ADDENDUM NO. 3

1904 / KVCC WHITNEY WING RENOVATIONS

Lewis + Malm Architecture

30JAN2020

KVCC WHITNEY WING RENOVATION
 FAIRFIELD, MAINE
 HVAC PIPING & DUCTWORK PLANS

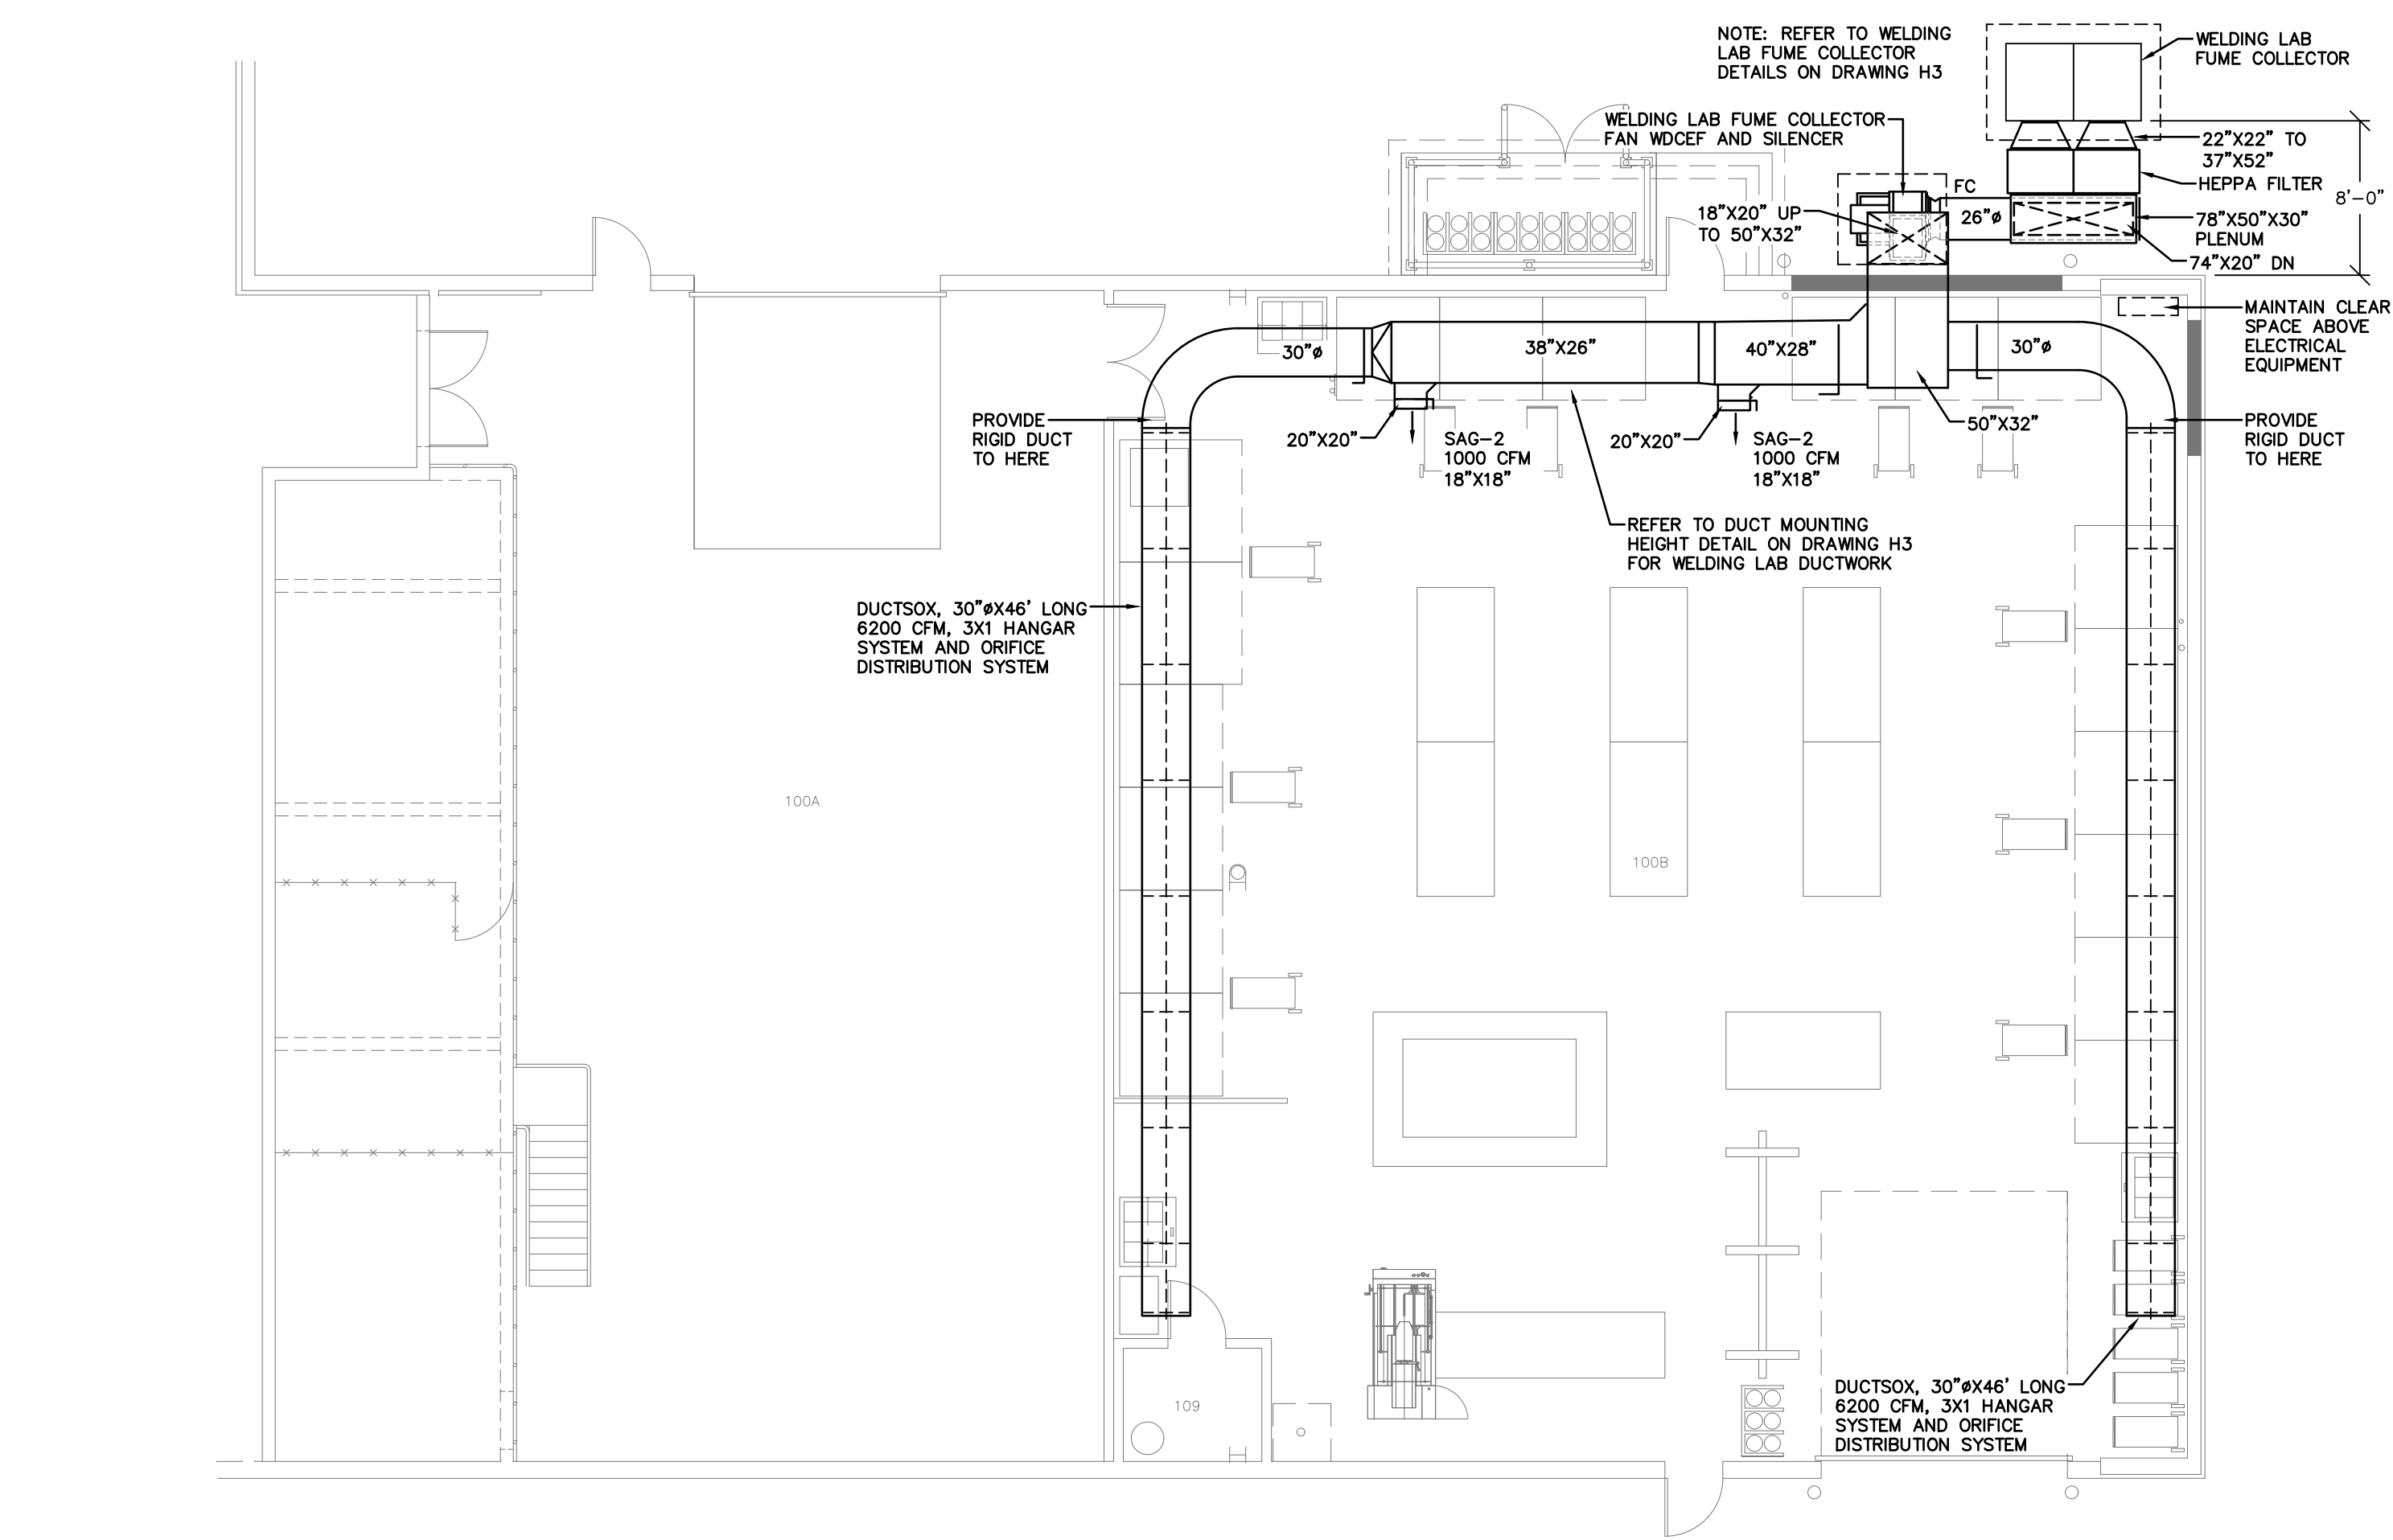
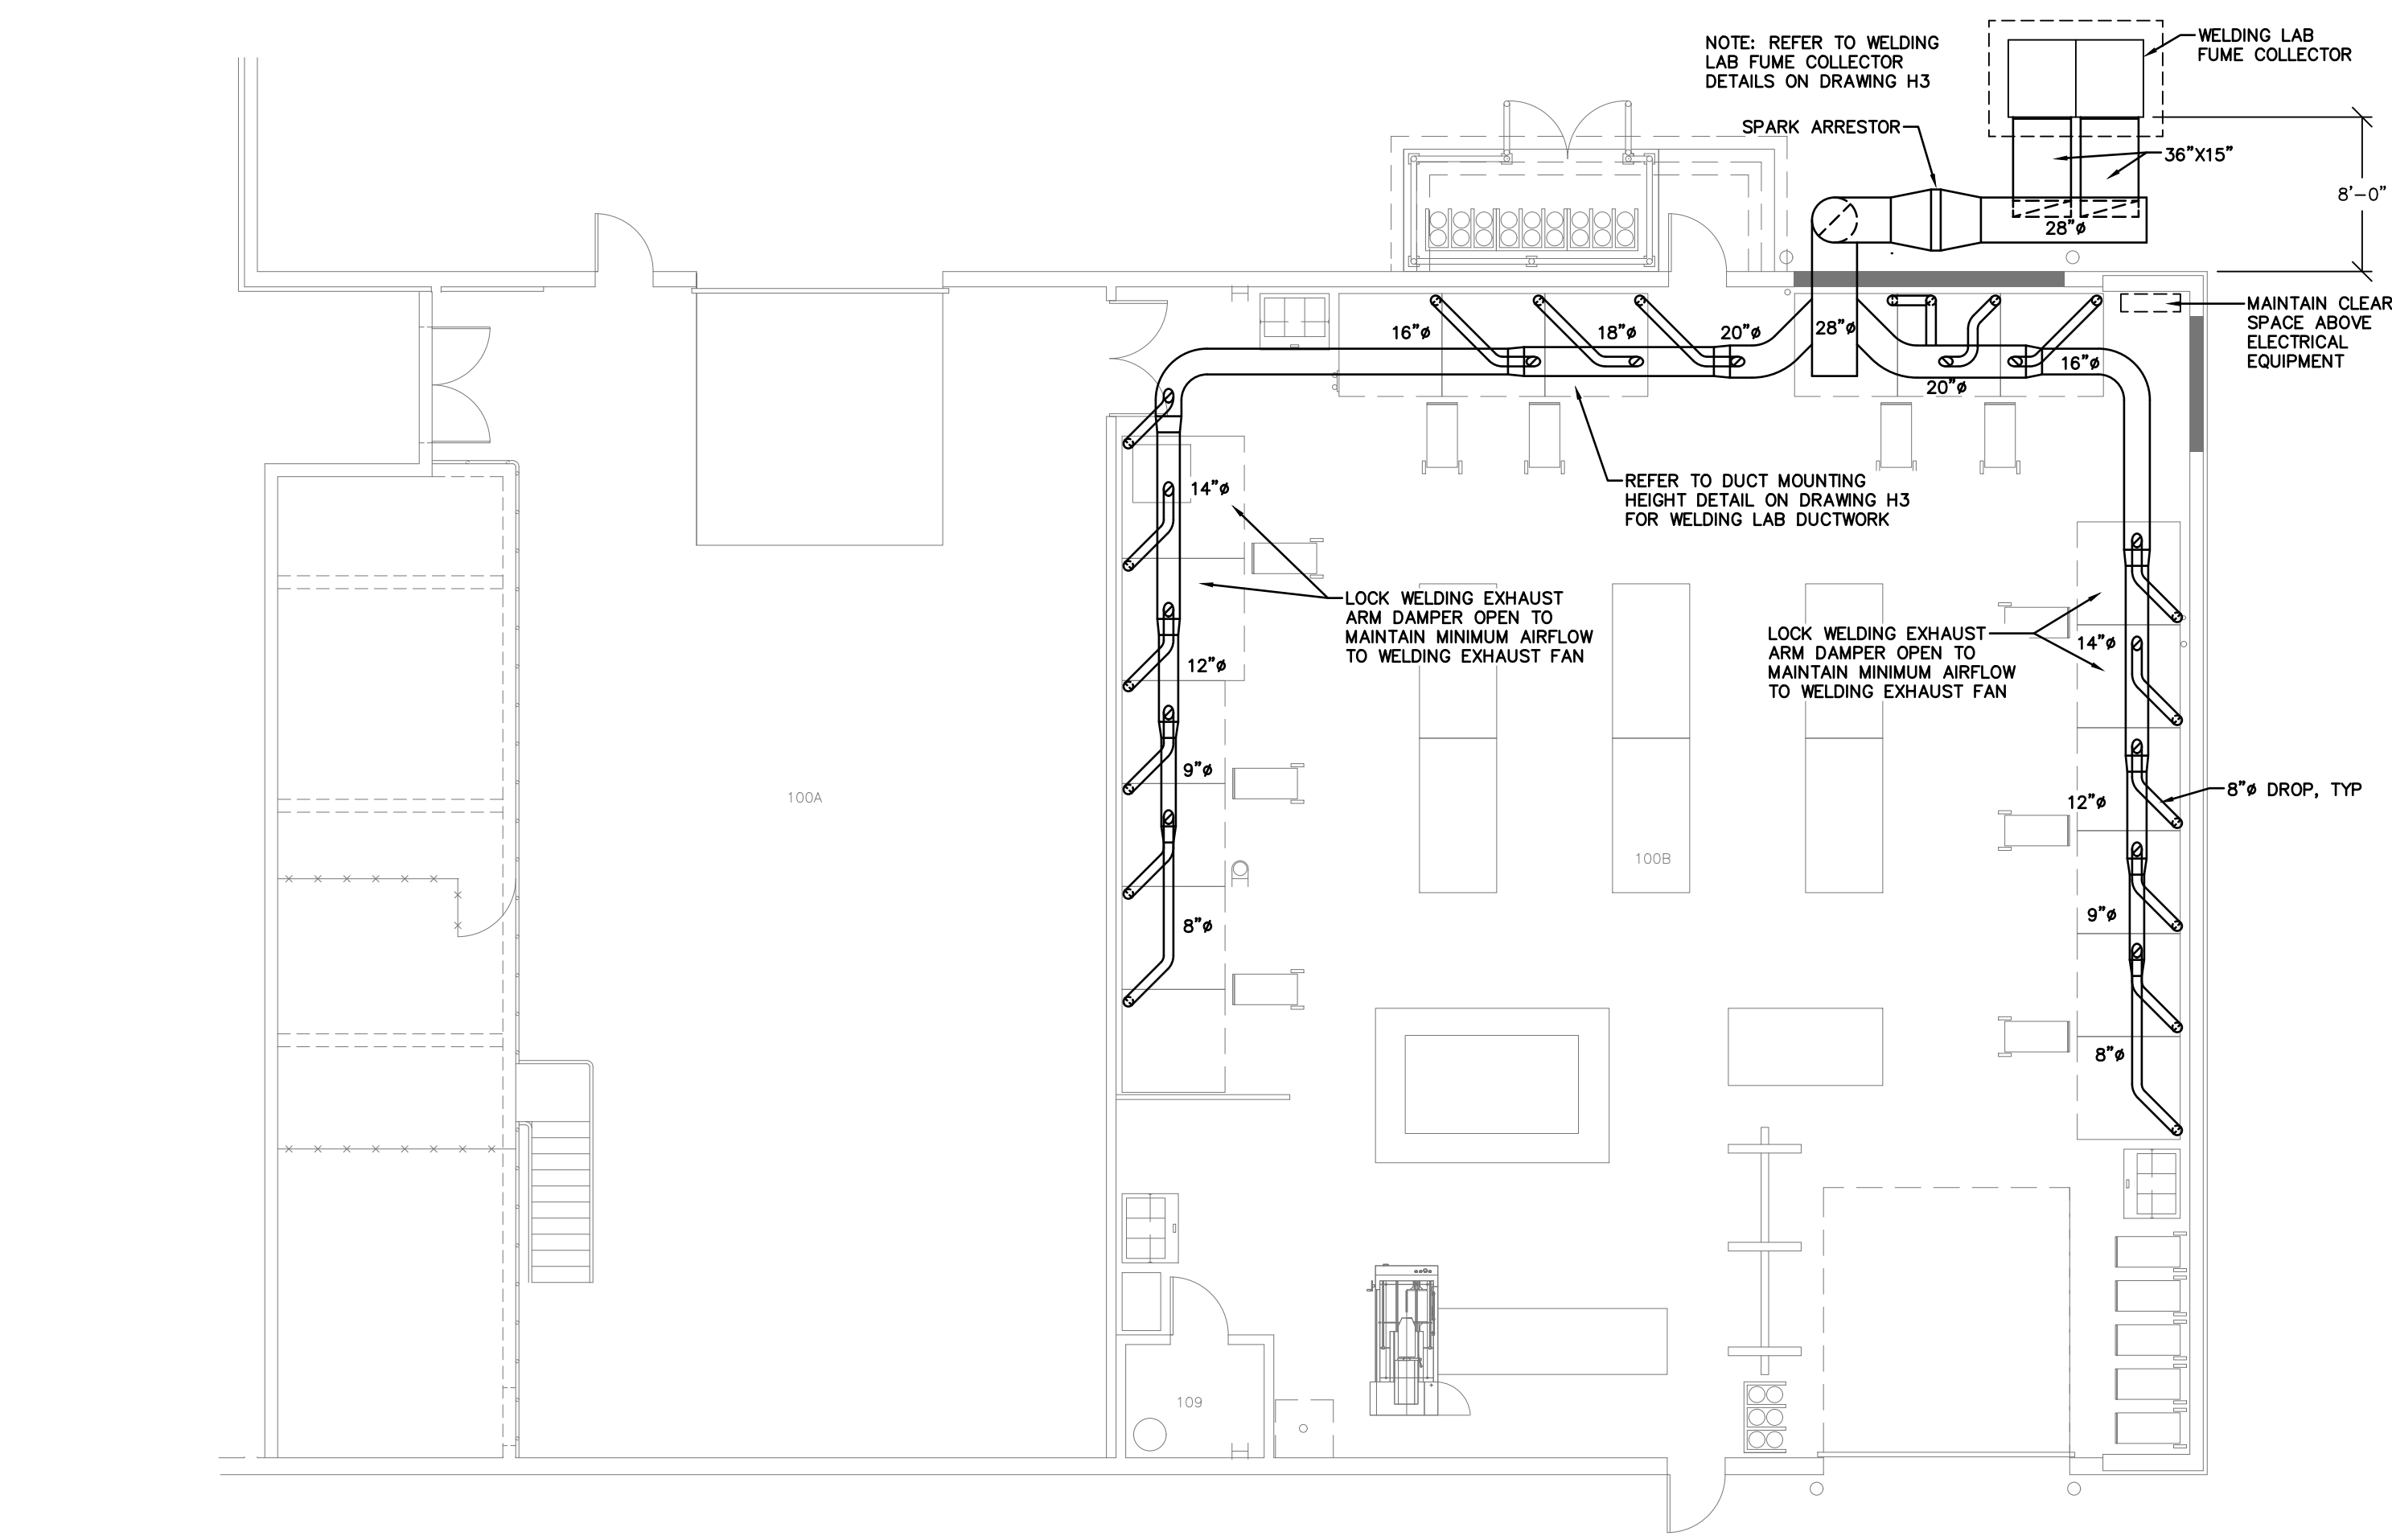
H1 ADD the drawing attached to this Addendum in its entirety (shows existing HWS/R

piping be rerouted around electrical equipment on the mezzanine).
